C2PC Request Letter

FCC ID: 2AI7A22210

The PCB layout has been changed, and the circuit is almost identical, with only minor adjustments made to some resistance and capacitance values. The main RF functions and frequencies have not changed significantly, and the specific differences are as follows:

1. Schematics

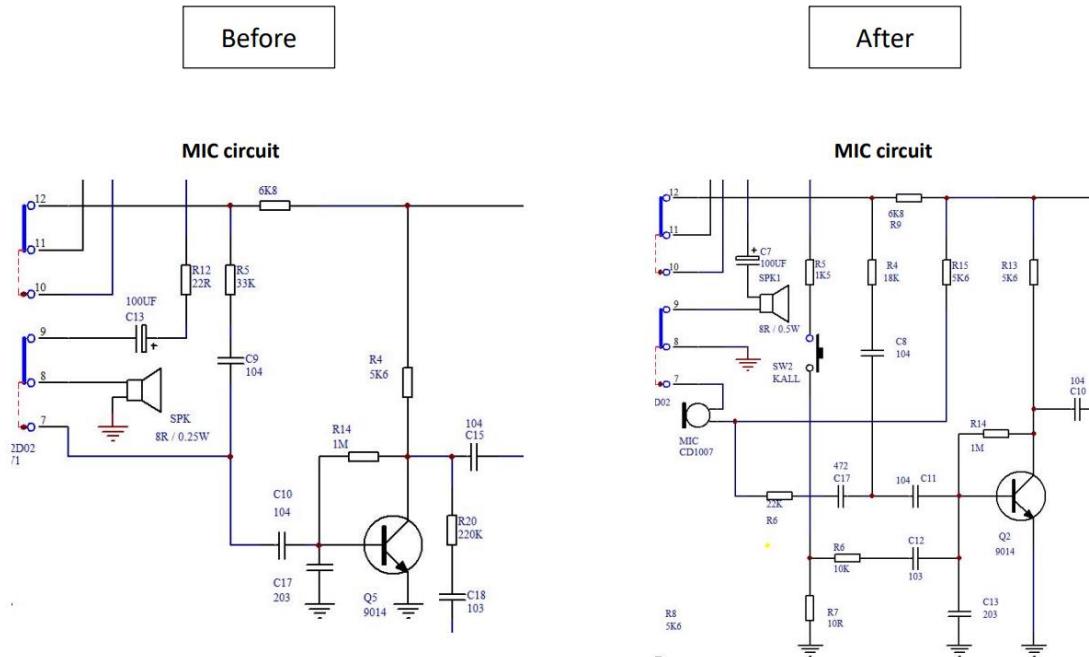
ITEM	Before	After
1	Electronic component	SPKER	MIC: CD1007 / R6: 5K6 / R15: 22K / C17: 472

2. PCB Layout

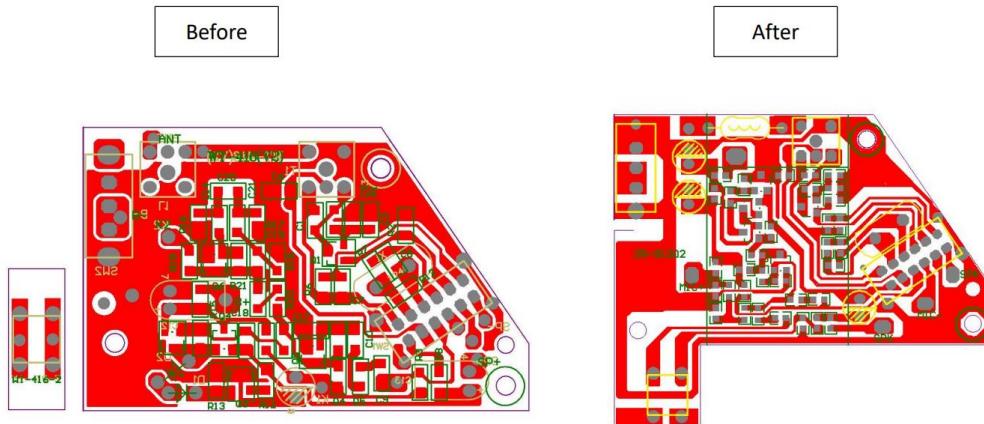
Item	Main Pcb
Description	<p>WT-416V1.0</p> <p>91002V1.0</p> <p>WT-416V1.0 and 91002V1.0 PCBs are shown with red dashed boxes indicating the area of change. The WT-416V1.0 PCB is green, and the 91002V1.0 PCB is green with a black component.</p>
